*Mountain Chute G2 Rewind and Excitation System Replacement
Notification of Approval of Connection Proposal
CAA ID Number: 2010-EX466*

**Project: Generator Rewind and Excitation System
Replacement for Mountain Chute G2**

CAA ID: 2010-EX466

**GENERATOR REWIND AND EXCITATION SYSTEM REPLACEMENT
FOR MOUNTAIN CHUTE G2
IESO EXPEDITED SYSTEM IMPACT ASSESSMENT – 2010-EX466**

Figure 1: Block Diagram of Excitation System

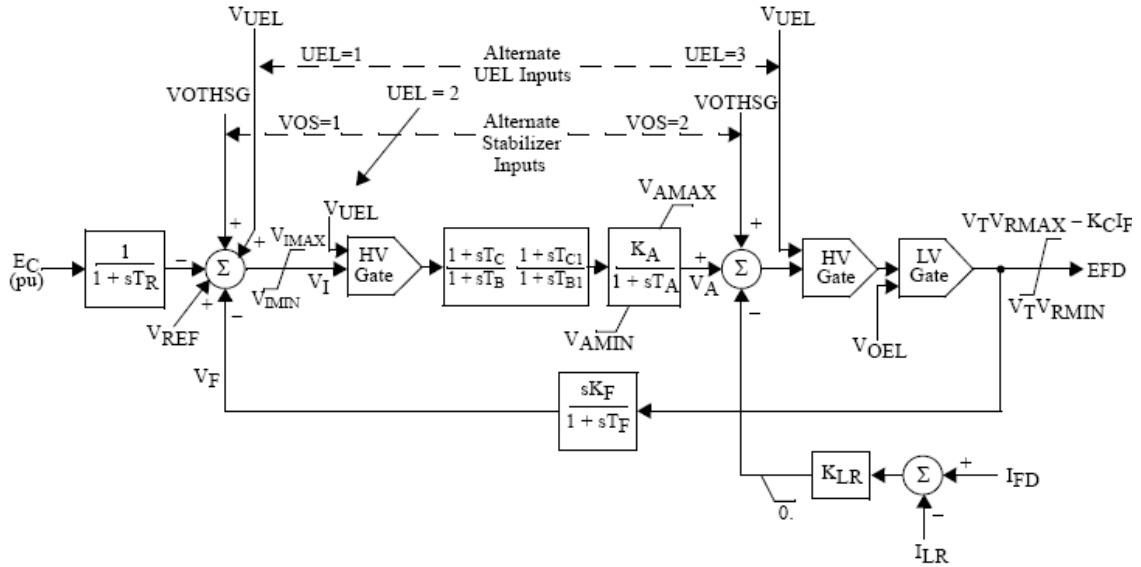
The block diagram of the proposed excitation system (Figure 1) shows the limit for the Efd is $V_t V_{rmax} - K_c I_{fd}$. As shown in Table 1, V_{rmax} is 4 and K_c is 0.088. Therefore, at rated terminal voltage and 160% of rated field current, field voltage, Efd, is 3.7, which is 190% of rated field voltage meeting Market Rules requirements.

Figure 3: Response Ratio Test Results (Positive Ceiling)

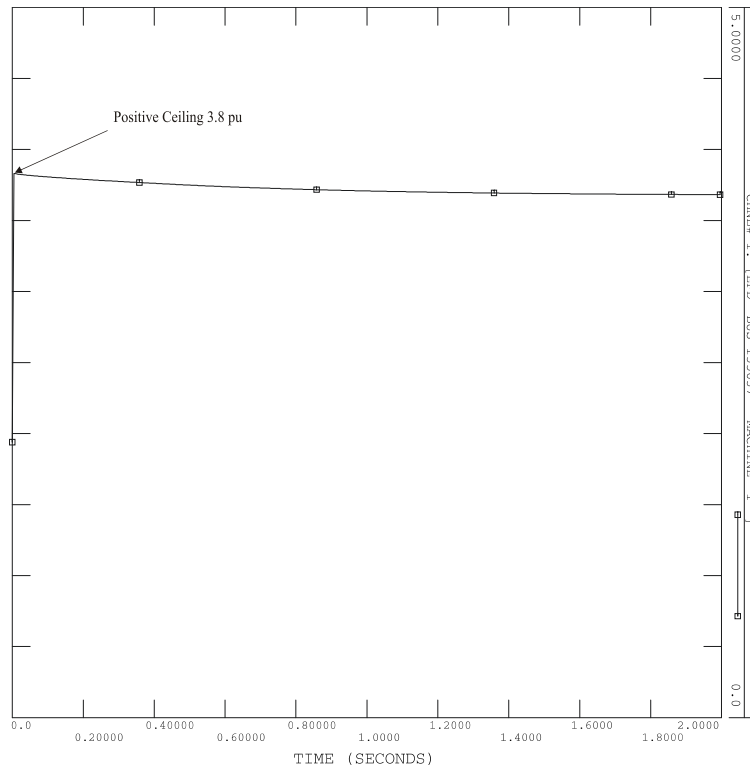
The plot in Figure 3 indicates that G2 has a positive ceiling of 3.8 pu and Figure 4 shows a negative ceiling of -2.8 pu. Compared to the required positive and negative ceilings, it can be concluded that the proposed excitation system meets the Market Rules requirements.

Figure 5: Open Circuit Test Results to a 5% step change in reference voltage

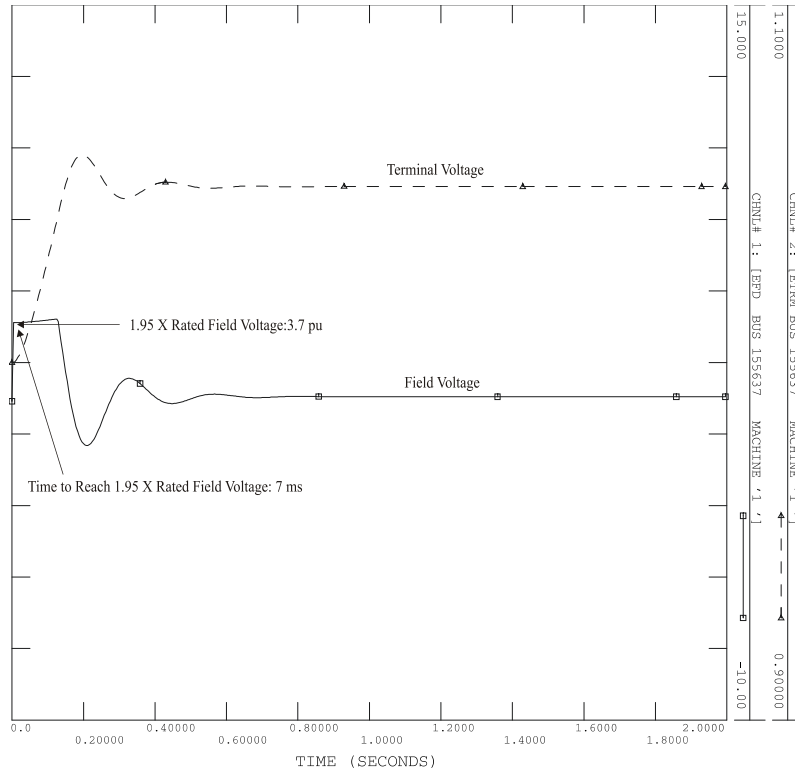
Figure 5 shows that $E_{fd_{OC}} = 1.15 \text{ pu}$ at $t = 0$. Therefore the required time to reach $1.95 * E_{fd_{rated}} = 3.7 \text{ pu}$ is:

Examination of Figure 5 shows that the exciter field voltage reaches 3.7 pu in 7 ms, meeting IESO requirements.

Figure 6: Open Circuit Test Results for -5% Step Change in Reference Voltage

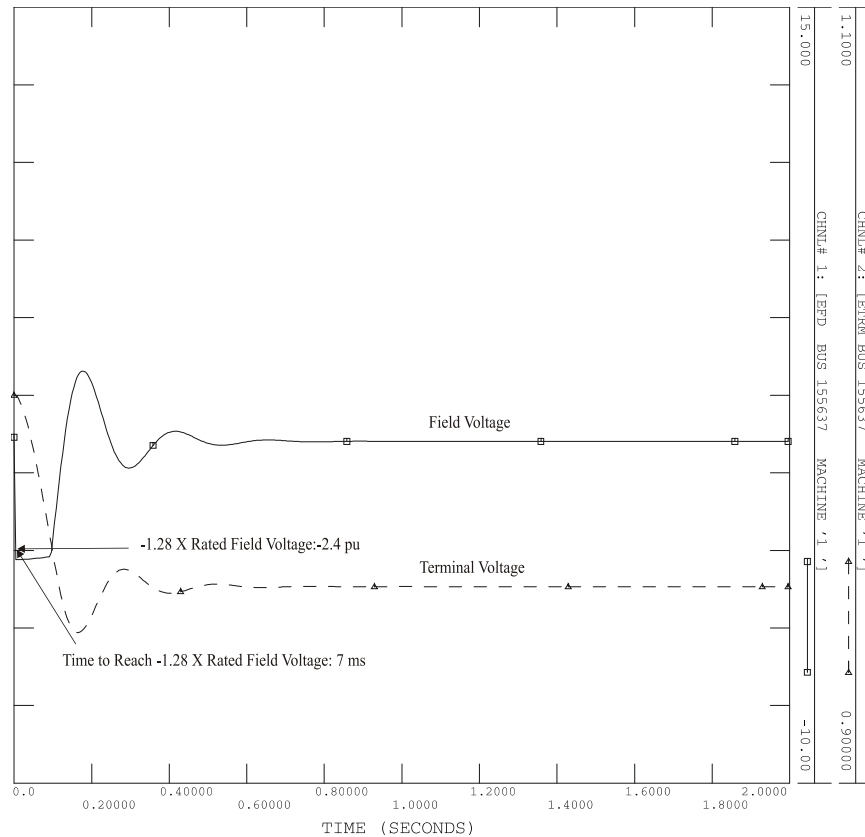
Figure 6 shows that $E_{fd_{OC}} = 1.15$ pu at $t = 0$. Therefore the required time to reach $-1.28 * E_{fd_{rated}} = -2.4$ pu is:

Examination of Figure 6 shows that, the exciter field voltage reaches approximately -2.4 pu in 7 ms, meeting IESO requirements.

Figure 7: Simulation Results of Rotor Angles

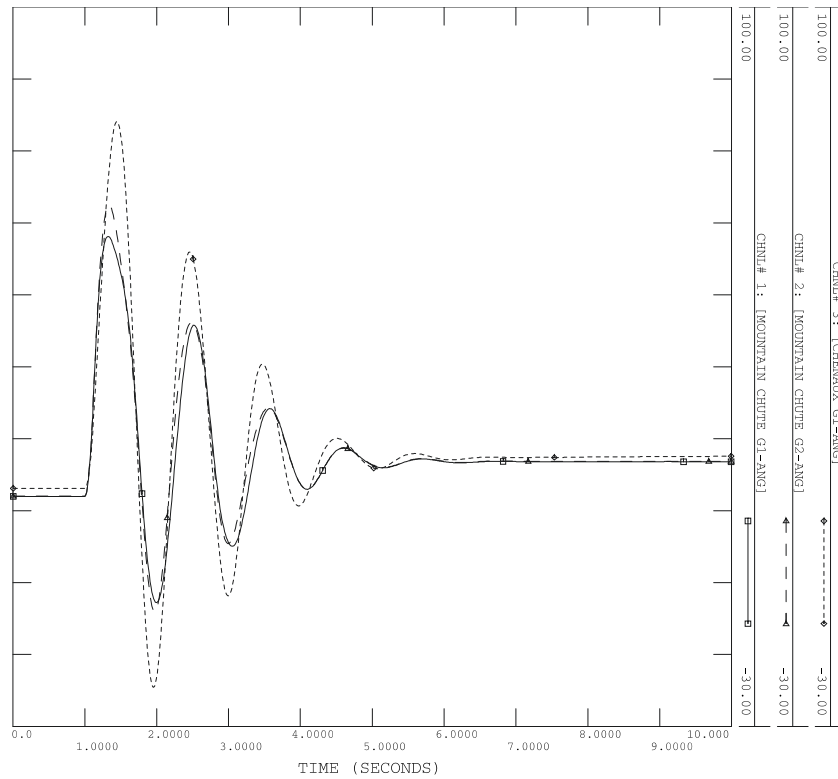
It can be seen that the system displays stable performance and the oscillations are well damped. Therefore, based on the transient stability study results it can be concluded that the proposed replacement of the exciter at Mountain Chute G2 would not adversely impact the reliable operation of the IESO-controlled grid.
